Application for Licence Amendment

Licence Number	L8739/2013/1
Licence Holder	Cable Sands (WA) Pty Ltd
ACN	009 137 142
File Number	DER2014/000656-1
Premises	Wonnerup Mineral Sands Mine 109 Sues Rd YALYALUP WA 6280 Being Lot 100 on Deposited Plan 65306, Mining Lease M70/360 and M70/569 and part of Miscellaneous Licences L70/159 and L70/161, as depicted in Schedule 1 of the revised licence
Date of Report	05/03/2021
Decision	Revised licence granted

Figure 4: Distance to residential receptors

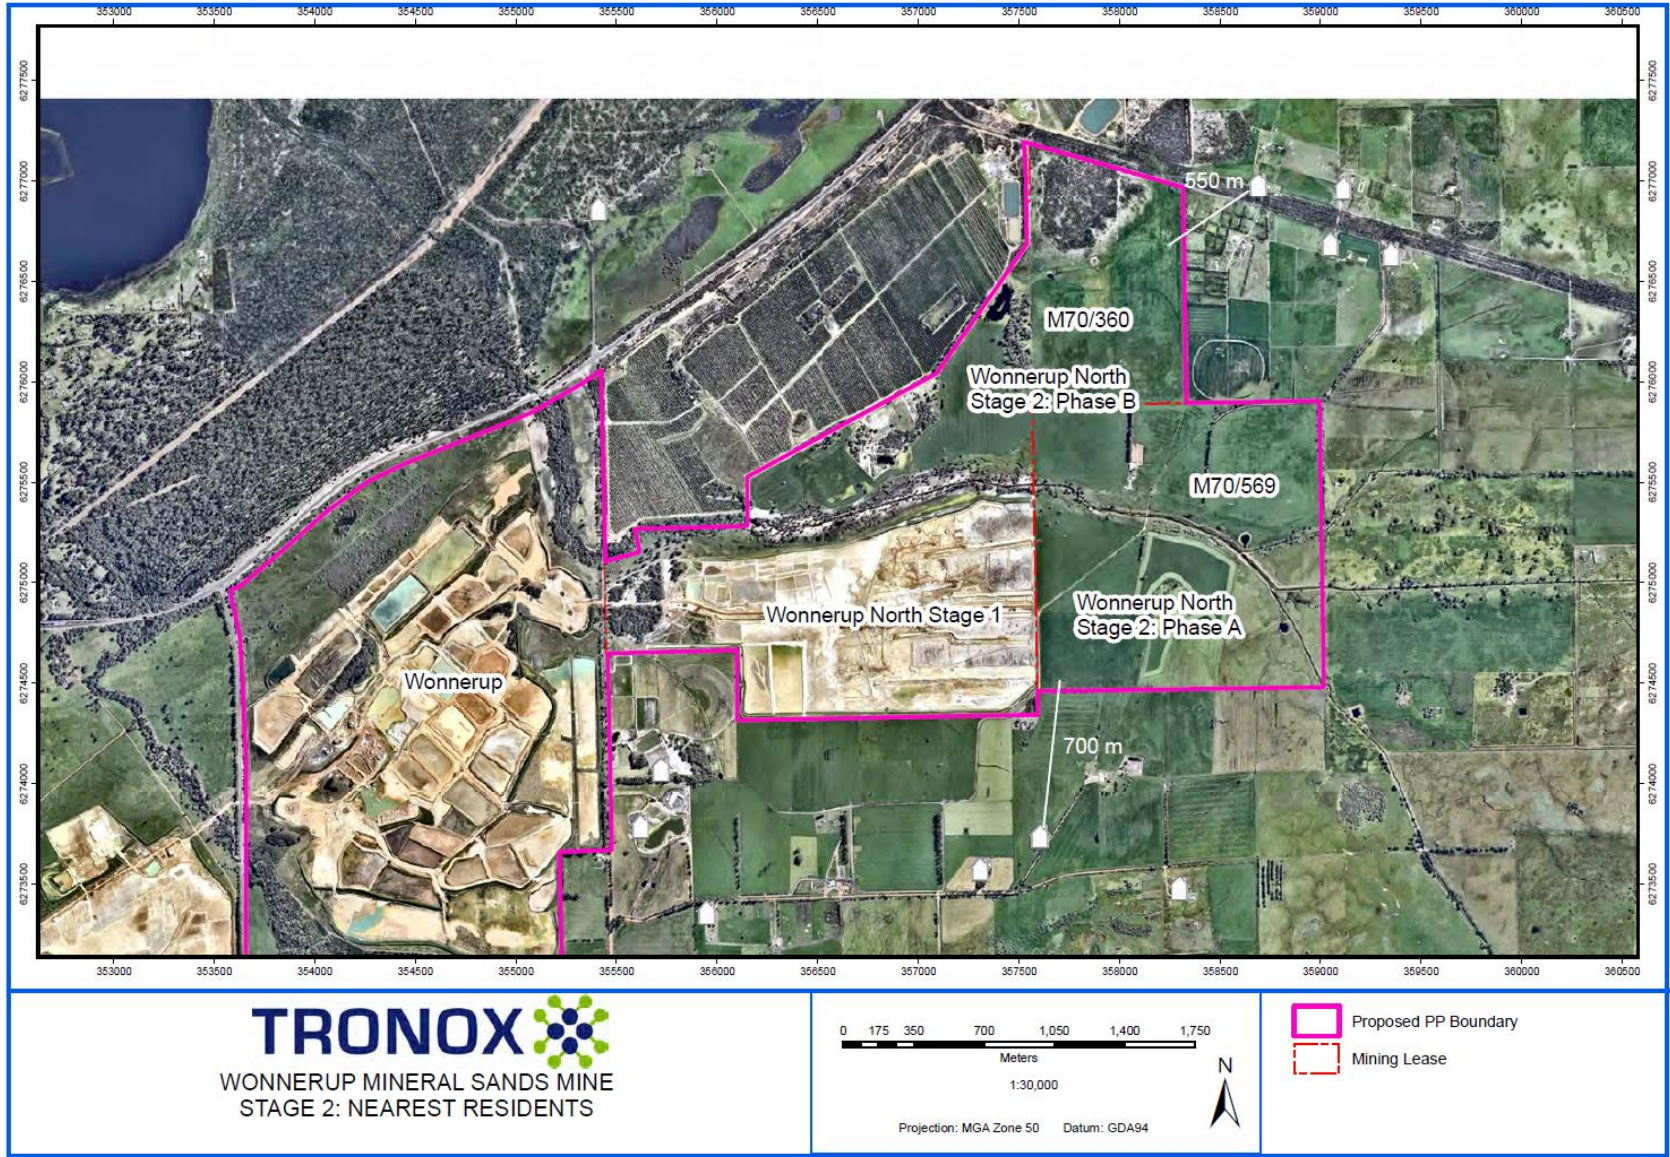
The locations of the closest residences are shown in Figure 4. The Licence Holder proposes no new dust monitoring for the phase A mining area, stating that residences to the south are adequately covered by existing AQ6.

The Delegated Officer has considered the location of receptors with respect to the mining area, in conjunction with the wind data in section 3. Residences to the north and east are more than 1.5km from the proposed mining area, so the Delegated Officer is satisfied that no monitoring in these directions is justified. The Delegated Officer considers that in many situations AQ6 may significantly underestimate the dust load to the residence to the south east of AQ6. To improve the accuracy of monitoring, an additional dust monitoring point AQ8 will be required in the south east corner of M70/569. As the receptor is about 1km away, it is considered that PM₁₀ and dust deposition monitoring is sufficient. Recent DWER internal technical advice states that deposited dust is appropriate for the assessment of amenity impacts. PM₁₀ is an appropriate parameter for monitoring impacts to human health.

Existing monitoring conditions provide a framework to assess impacts to receptors, and trigger equipment relocation or cessation of mining if required. The only residences within 1.5km of the Wonnerup North Stage 2 Phase A are to the south. Existing monitoring point AN6 is sufficient to monitor noise at these receptors. There are also receptors within 2km to the north and east.

The only existing licence limit in the monitoring conditions is for TSP. To trigger investigation should the PM₁₀ at any monitoring point exceed the *National Environmental Protection (Ambient Air Quality) Measure* (Ambient air NEPM), a target to not exceed 50 µg/m³, averaged over 24-hours, is introduced in Table 3.4.2.

Figure 5: Diagram showing the progressive construction of topsoil (external) and ore (internal) noise bunds

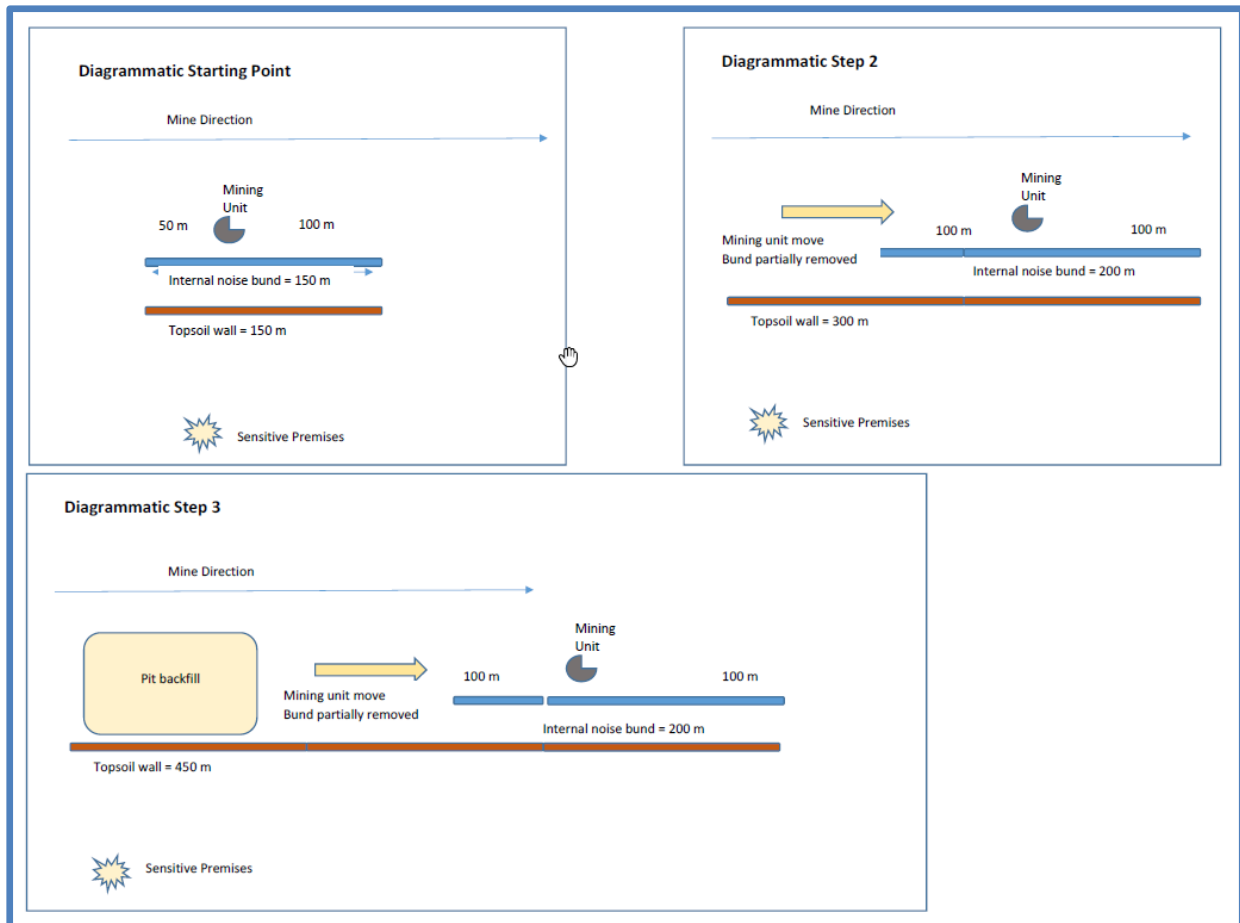
In previous mining areas, the Licence Holder has constructed noise bunds around the perimeter of the mining area before the commencement of mining operations. Due to land access limitations (farming continuing on as much land as possible that is not being actively mined), this is not possible for Wonnerup North stage 2 phase B. The Licence Holder proposes to progressively construct and deconstruct noise bunds throughout the mining timeline as required.

The original noise modelling assumed the placement of an external noise bund along the southern perimeter of M70/569 and along the southern bank of the Abba River, the northern boundary of the mining area. DWER requested a sensitivity analysis to show the impact of this bund being incomplete or not present. This was provided (Wood 2021) and shows that in a worst-case scenario (no external topsoil bund, only internal ore bunds within 100m of the mining unit), the Noise Regulations can still be met. The noise bunds close to the mining unit provide the greatest noise mitigation, with the external bunds providing some additional protection from noise as well as dust and visual screening. The Delegated Officer therefore considers the proposal to allow construction of noise bunding progressively (at least 100m in advance of the mining unit) to be reasonable.

The Delegated Officer considers that with the above conditions in place, there may be a low level impact to amenity at off site residential receptors, giving a consequence rating of **Moderate**. It is **Possible** that this impact could occur at some time, giving a risk rating of **Medium**.

Figure 6: Proposed Upgrades to Discharge Point W2

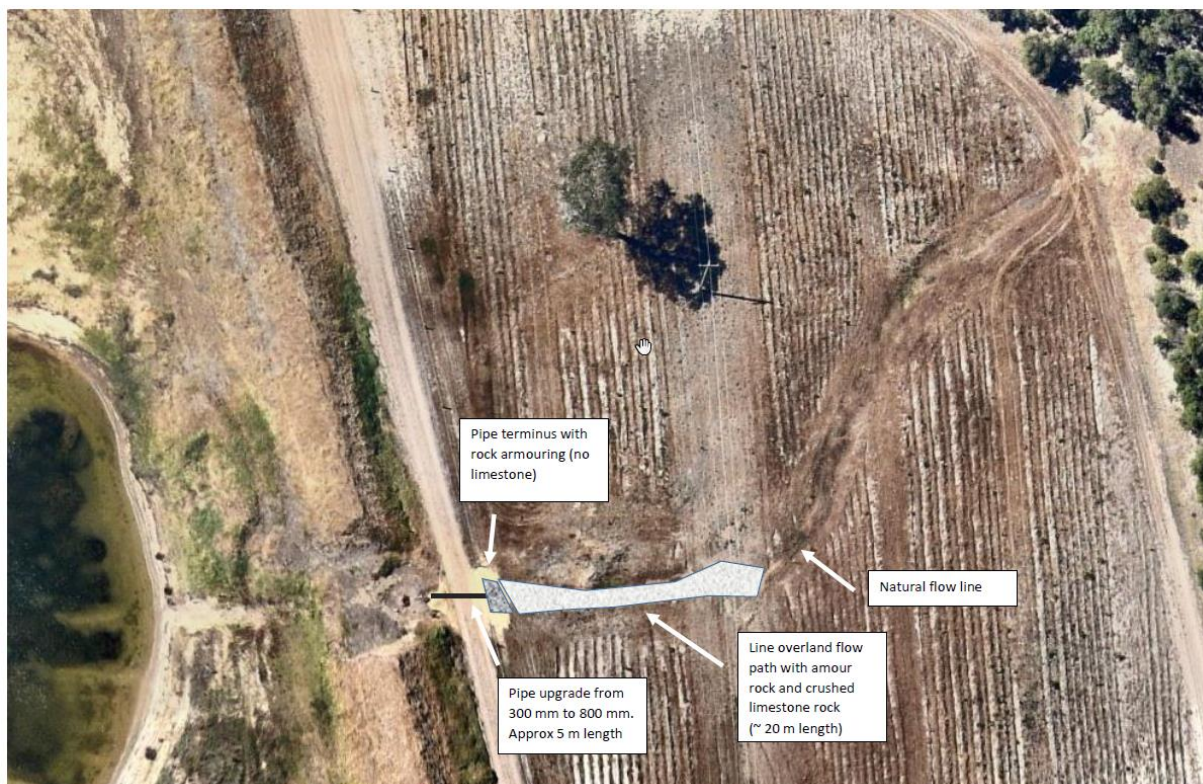
W2 will be upgraded to reduce the risk of erosion at the discharge point, as per Figure 6. The surface water impact assessment (RPS 2014) identified the narrowest constriction of the Abba River, between proposed flood bunds, to be on tenement M70/569. Discharge point W2 is downstream of this constriction, which reduces any flooding risk associated with the discharge.

Design components critical to erosion control at discharge point W2 are specified in condition 1.2.5.

Figure 7: Mean Daily flow rates at the North Western corner of M70/360

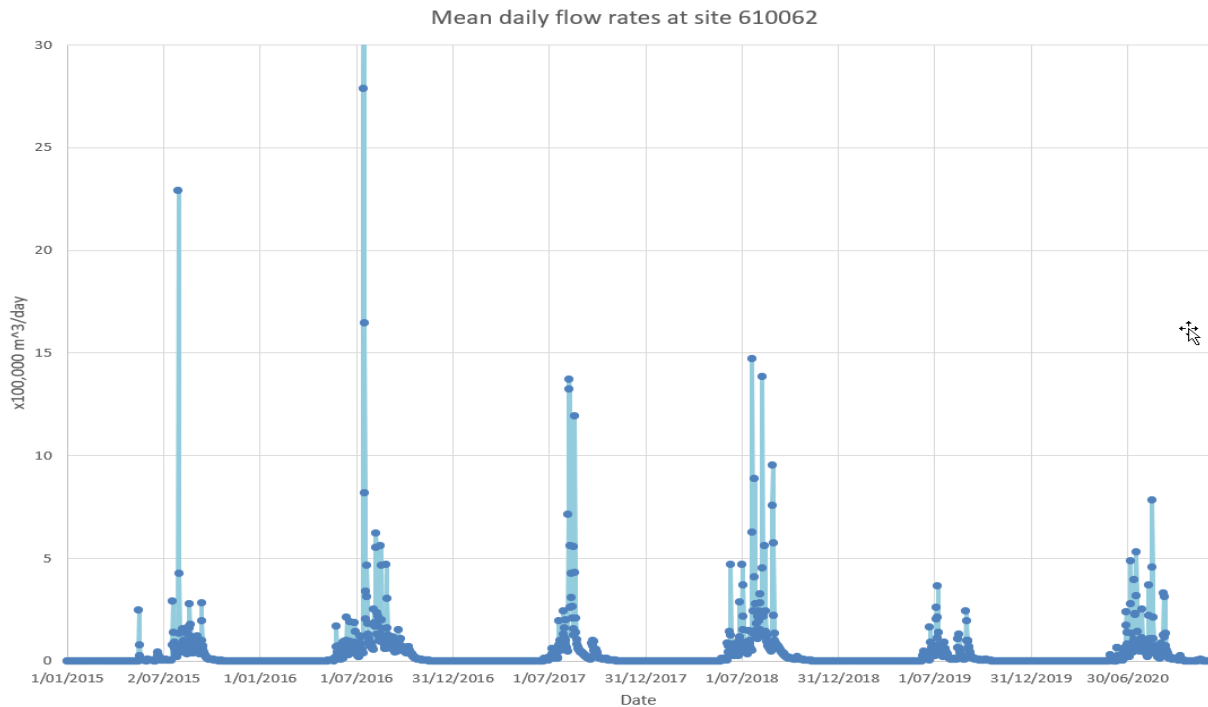
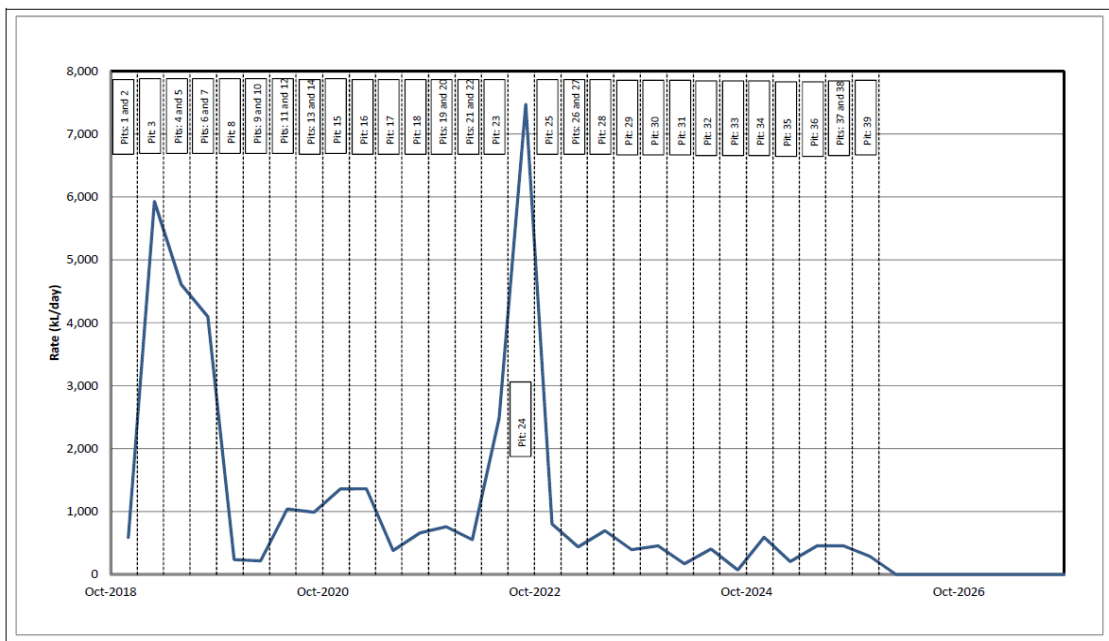
The mine dewater component will likely result in an increase in flow rate of the Abba River. Figure 7 shows the mean daily flow rates since 2015 on the Abba River, at DWER's site 610062 which is located at the North Western corner of M70/360. There is typically no flow in Summer (only pools), then flow during the winter months which correlate strongly with rainfall.

If all mine water was discharged during the peak predicted dewatering period of 7,500kL/d in Q3 2022, the Delegated Officer considers that given the magnitude and variability of winter flow rates for the Abba River presented in Figure 7, 7,500m³/day for a few months is unlikely to make a noticeable change to the flow volume in the Abba River. If pit 24 is mined at a dryer time of year, discharge is likely to be low as more of the dewater will be used on site. The lower dewatering rate at other times may slightly extend the flow period of the river, but it is unlikely to be outside of natural variability.
